Application Serial No. ....10/821,781  
Filing Date..... April 9, 2004  
Confirmation No.....1454  
Appellants.....Stefan Barkaro, *et al.*  
Group Art Unit.....2614  
Examiner .....Jamal, Alexander  
Attorney Docket No. .... LAN0033US  
Title: .....ECHO CANCELING ARRANGEMENT

APPEAL BRIEF

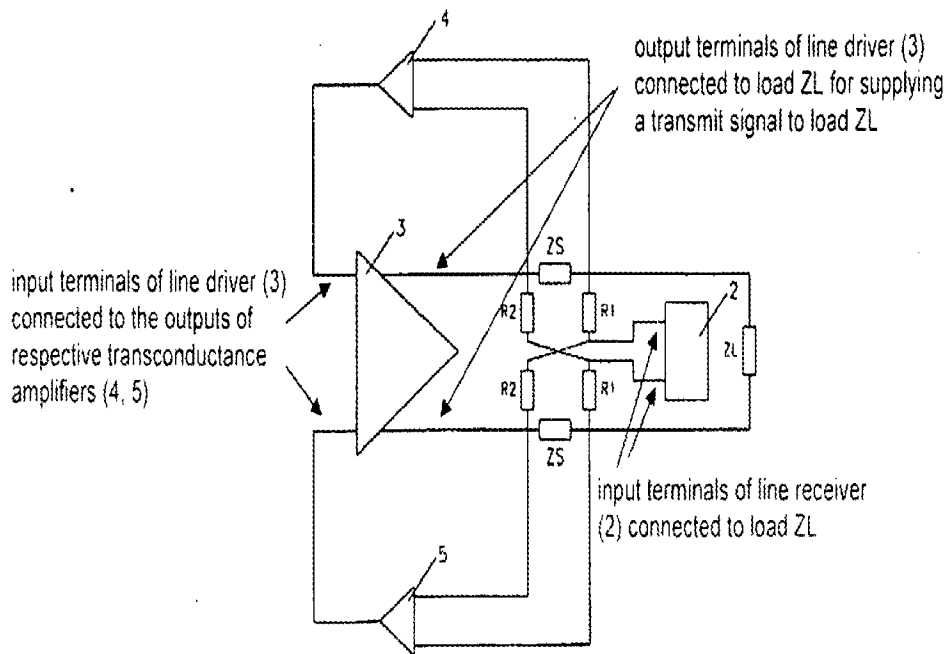
The drawings of the present application are objected to under 37 CFR §1.83(a) as, allegedly, failing to show every feature of the invention specified in the claims. In particular, the objection states that, “the means for coupling the claimed ‘transmit signal’ along with the claimed input terminals receiving the signals from the transductance stages must be shown or the feature(s) canceled from the claim(s).”

With regard to **Claim 1**, Fig. 2 of the present application is shown below, with annotations, to show certain features of the rejected claim. Fig. 2 shows a line driver **3** having output terminals connected to a load **ZL** to supply a transmit signal to the load **ZL** and a line receiver **2** having input terminals connected to the load **ZL** to simultaneously receive a received signal from the load **ZL**. Fig. 2 further shows an arrangement, including resistor bridge **R1**, **R2**, to cancel the transmit signal on the input terminals of the line receiver **2**. The output terminals of the line driver **3** are shown as being connected to the load **ZL** via equal first impedances **ZS** and the input terminals of the line receiver **2** as being connected to the load **ZL** via equal first resistors **R1** and to respective ones of the line driver output terminals via equal second resistors **R2**.

With regard to all of the appealed claims, particularly independent Claims 1, 3, and 7, the rejection states that the claims recite “first impedances which are ‘complex impedances to match the load impedance, and are of an impedance value that is much smaller than the impedance value of the load’.” The Appellants respectfully submit that the rejection includes an inaccurate characterization of the claimed subject matter. Instead, what is actually recited is:

The Appellants further submit, respectfully, that the connection by which signals are transmitted from the out terminals of the respective transductance amplifiers **4, 5** to the input terminal of the line driver **3** is clearly depicted in Fig. 2 of the present application. That is, the drawing fully illustrates the coupling of the respective transductance amplifiers **4, 5** with the respective impedances **ZS** and the outputs thereof to the input of line driver **3**.

In Fig. 2, the notation “Z” denotes that the first impedances “**ZS**” may be complex, as claimed. At [0028] of the published application, first impedances **ZS** are described as being complex, and it is further described that first impedances **ZS** may be of an impedance value that is much smaller than an impedance value of the load **ZL**, as in Claim 1.

smaller than an impedance value of the load so that a drive/termination impedance of the line driver matches the load impedance. The matching described in the specification, therefore, refers to the drive/termination impedance of the line driver, including impedances **ZS**. Accordingly, it is the drive/termination impedance of the line driver that matches the load impedance, as recited in Claim 1, and not the first impedances that match the load as set forth in the rejection.

Further, at [0031] of the application, the drive/termination impedance of the line driver **3** is described as equaling  $k \times \mathbf{ZS}$ , whereby “k” is a gain-related function and “**ZS**” is the value of the first impedance. The drive/termination impedance of the line driver, therefore, is a function of both gain and the value of the impedances **ZS**. Thus, the drive/termination impedance of the line driver **3** can be matched to the load when  $k \times \mathbf{ZS} = \mathbf{ZL}$ , as currently recited.

The rejection states, even further, that one of ordinary skill would not be able to determine what the relative size, *i.e.*, “much smaller,” would be as recited in Claim 1. In respectfully disagreeing, the Appellants submit that one of ordinary skill would know, by the aforementioned formula from [0031] of the specification, that “much smaller” could easily be approximated by the load impedance **ZL** divided by the gain factor k, *i.e.*,  $\mathbf{ZS} = \mathbf{ZL} \div k$ . That is, “much smaller” is easily determined to be approximately 1/k of the load impedance.

Fig. 2 also shows that the transconductance amplifiers **4, 5** are provided to sense the voltage across the first impedances **ZS** and to supply corresponding currents to respective ones of the line driver input terminals, as claimed. Thus, each feature of Claim 1 is sufficiently illustrated and described in the application to enable one skilled in the art to practice that which is claimed, per the requirements of 35 U.S.C. §112, first paragraph.
